Re: Petition No. 1313 – Petition of DWW Solar II, LLC for a Declaratory Ruling that no Certificate of Environmental Compatibility and Public Need is Required for a 26.4 Megawatt AC Solar Photovoltaic Electric Generating Facility in Simsbury, Connecticut

**DWW SOLAR II, LLC'S RESPONSE TO THE CONNECTICUT SITING COUNCIL'S
SECOND SET OF INTERROGATORIES RELATED TO THE PROJECT'S D&M PLAN**

WATER QUALITY CLASSIFICATIONS SIMSBURY, CT

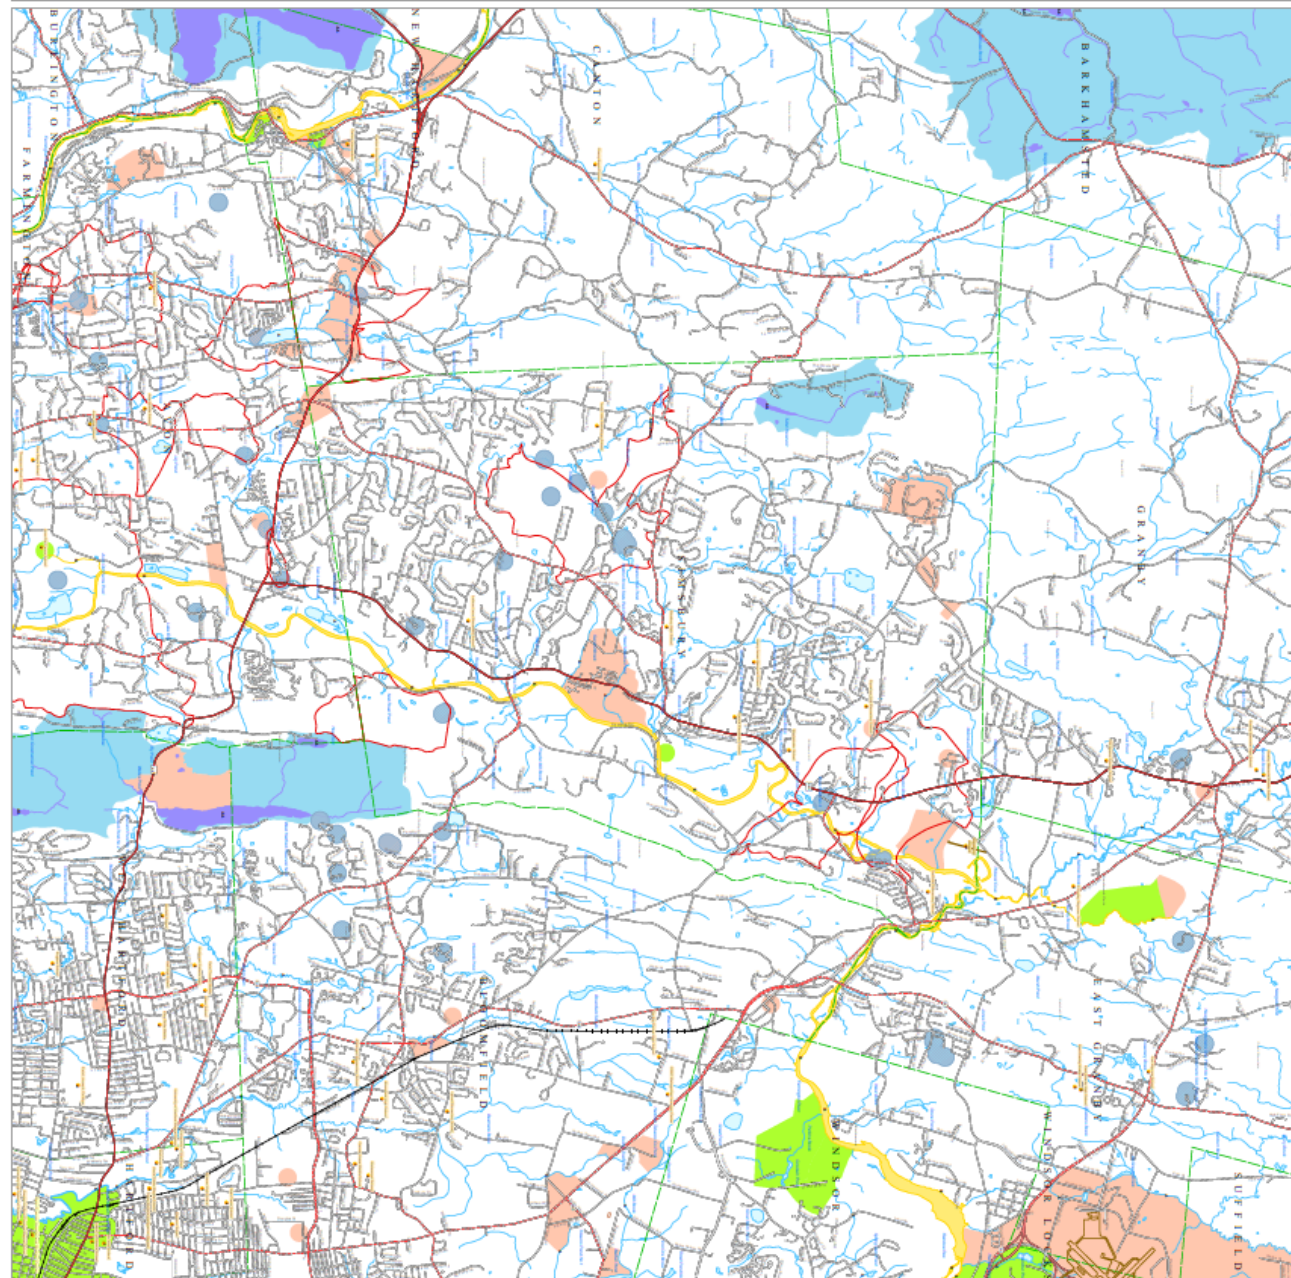
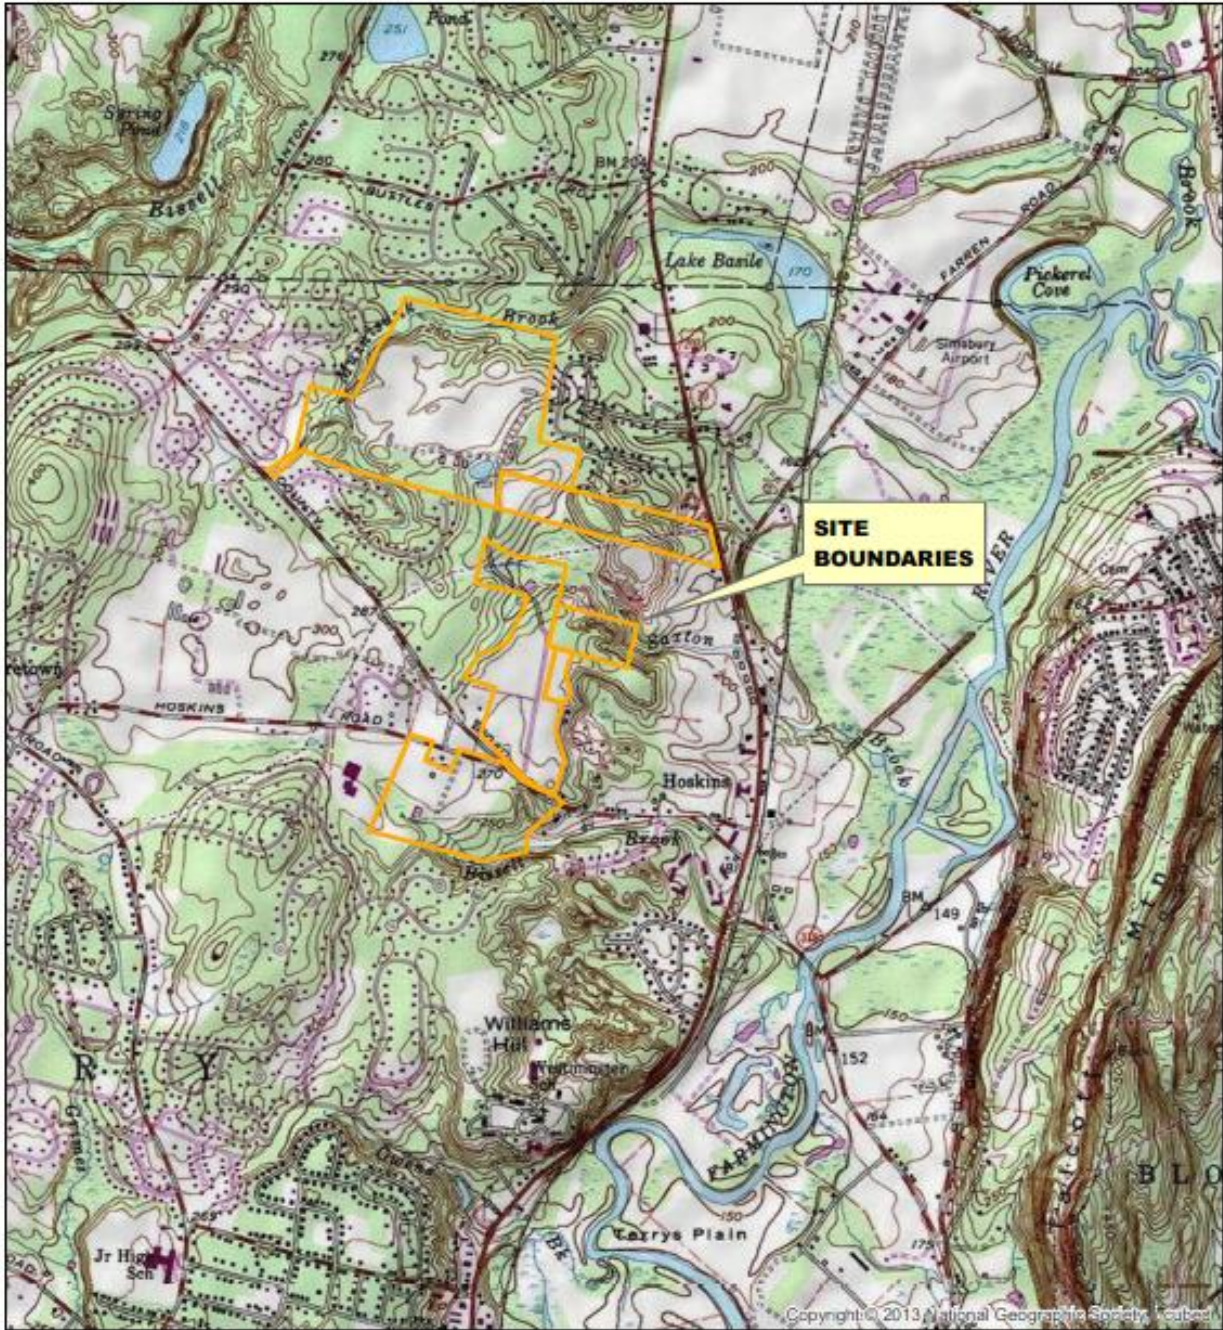
9. The water quality designations of the receiving water bodies should be described in the SWPCP, including a discussion of whether the water bodies are "impaired" or "high quality."

Munnisunk Brook, Saxton Brook, and Bissell Brook are identified as Class A waters on the CT DEEP Water Quality Classifications Map for Simsbury, CT (CT DEEP, October 2018). The Farmington River is identified as a Class B water on the Water Quality Classification Map. Per the CTECO MS4 Map Viewer, Munnisunk Brook, Saxton Brook, Bissell Brook, and the Farmington River in the vicinity of the site are not impaired waters, indicating that these waters meet the Designated Uses and Criteria established in the CT DEEP Water Quality Standards (2011). These waters are not designated as Outstanding National Resource Waters. A screen shot from the online map viewer and a copy of the Water Quality Classifications Map are included as Attachment A.
